Submission to the Water Plan (Moreton) 2007 Amendment

Lockyer Water Users Forum Incorporated

Version: 25 January 2019

Figure 2.1 Model area and boundary conditions (after DNRM, 2000)

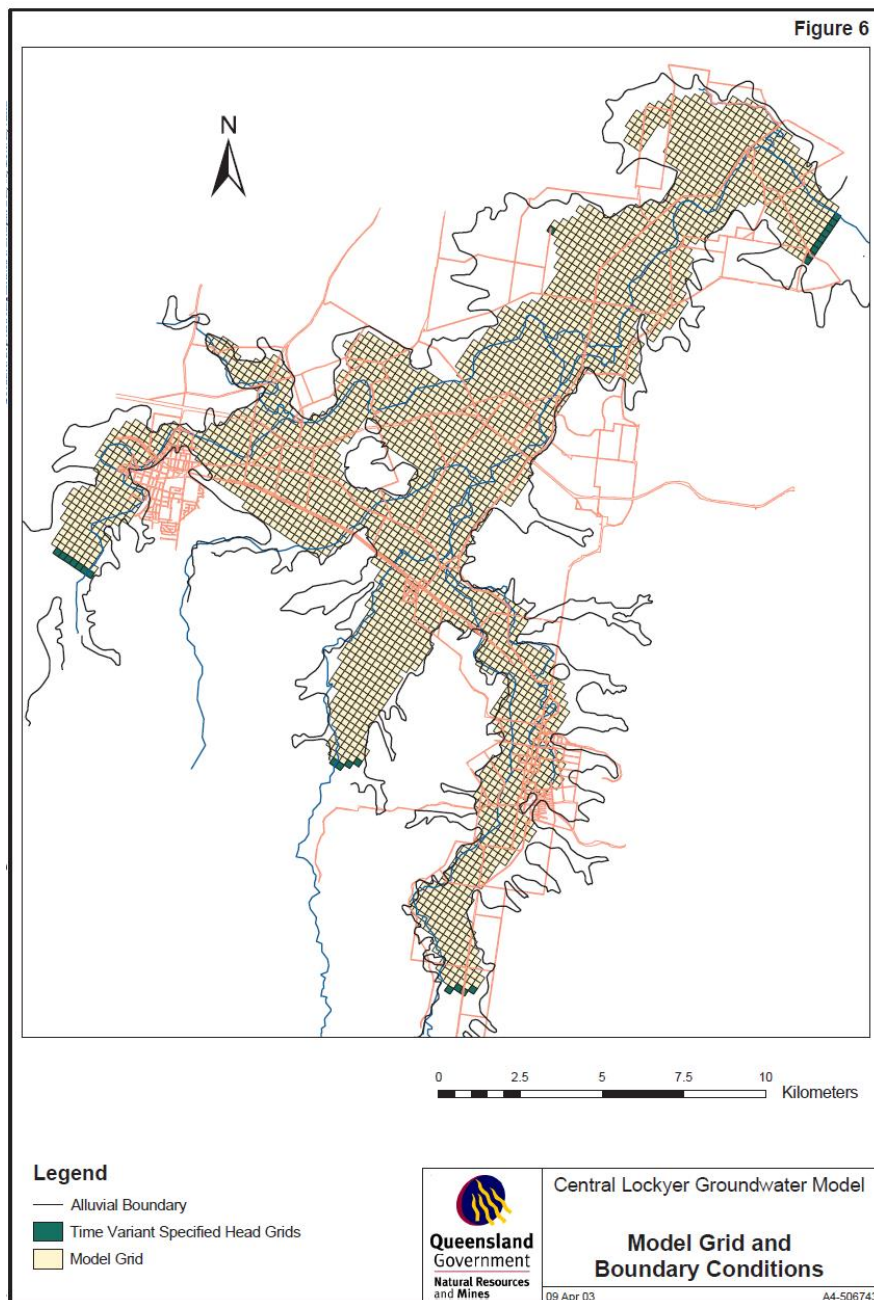
The modelling software used were MODFLOW 88, PMWIN 4 and PEST. The model simulation period is from July 1987 to July 1997. The model domain consists of 15,000 200 m by 200 m cells, of which 3,214 cells are active (Figure 2.1).

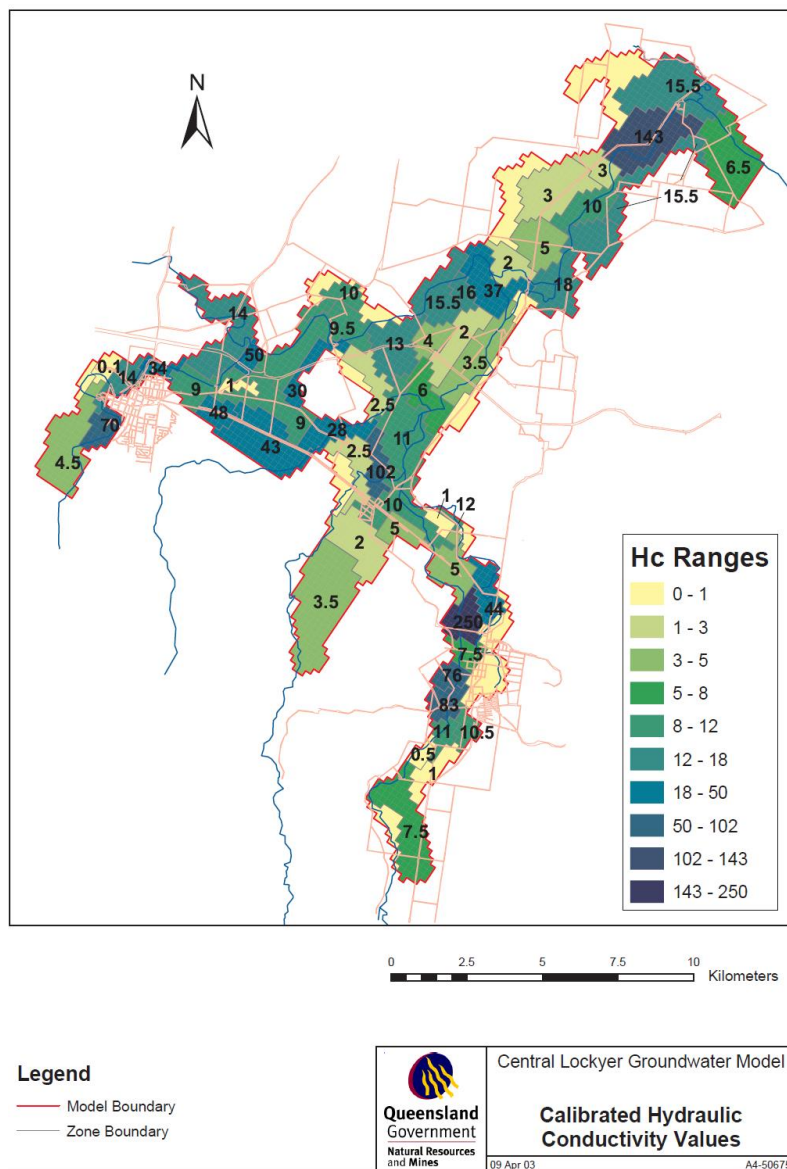
Fifty-three (53) zones are assigned for the 3214 active cells are, in our opinion, contrary to the well-developed modelling practise of working from simple toward complex. It also suggests that the big picture, model-wide calibration, will be lost through a set of tedious local calibrations. Such a model will undoubtedly calibrate, but would it be realistic?

Figure 15, reproduced below, indicates the existence of zones with straight, unnatural looking boundaries and some zones with huge contrast in adjoining hydraulic conductivity: 250 m/day vs 5 m/day or 7.5 m/day and 143 m/day vs 3 m/day. It is difficult to comprehend how such alluvial system developed and how these contrasts can be justified. In our view, the anomalously high values are the artefact of adopting a one-layer model and excluding the sandstones. The model probably initially dealt with these by very high heads and in subsequent error minimisation runs attempted to distribute the recharges locally. Because there was not enough transmissivity (product of hydraulic conductivity and thickness) in the one-layer alluvium, the thickness being limited the hydraulic conductivity had to be increased.

The effects can be seen in Figure 15 that indicates the existence of zones with straight, unnatural looking boundaries and some zones with huge contrast in adjoining hydraulic conductivity: 250 m/day vs 5 m/day or 7.5 m/day and 143 m/day vs 3 m/day.

Figure 4.1 Trigger bores and management zones (after DES, 2018)

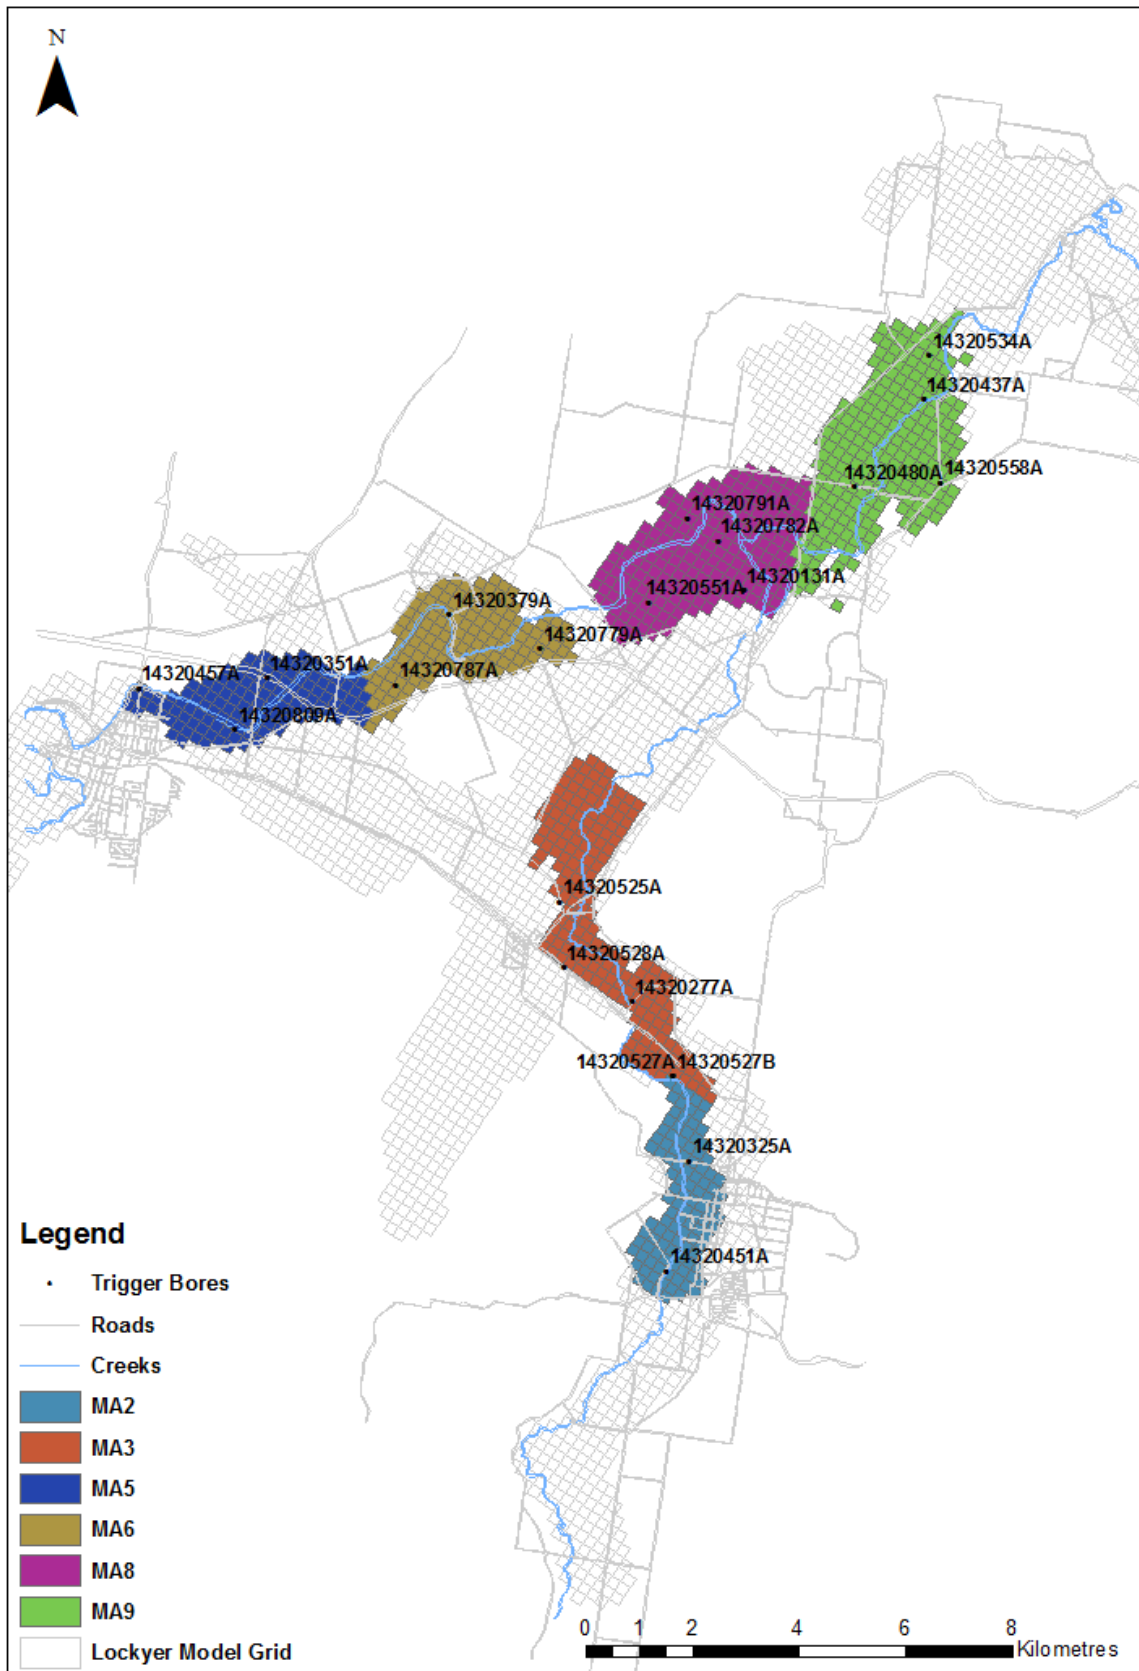
Table 2 shows trigger bores within each management zone, trigger levels and corresponding AA level for that bore. There are in total 21 trigger bores used for AA calculations in this model. The locations of the trigger bores are shown in Figure 3 along with the management zones. (see Figure 4.1).

The proposed announced allocation level for each management zone is calculated by averaging the AA levels for trigger bores in that management zone. The AA is implemented at the beginning of the water year on 1 July and is fixed for the remainder of the water year. Owing to the minimum announced allocation level of 40% (i.e. a minimum pump rate of 40% aspirational volume), there may be times when the simulated groundwater level approaches the base of the model due to the fixed minimum announced pump rate. This is further discussed in Section 5.
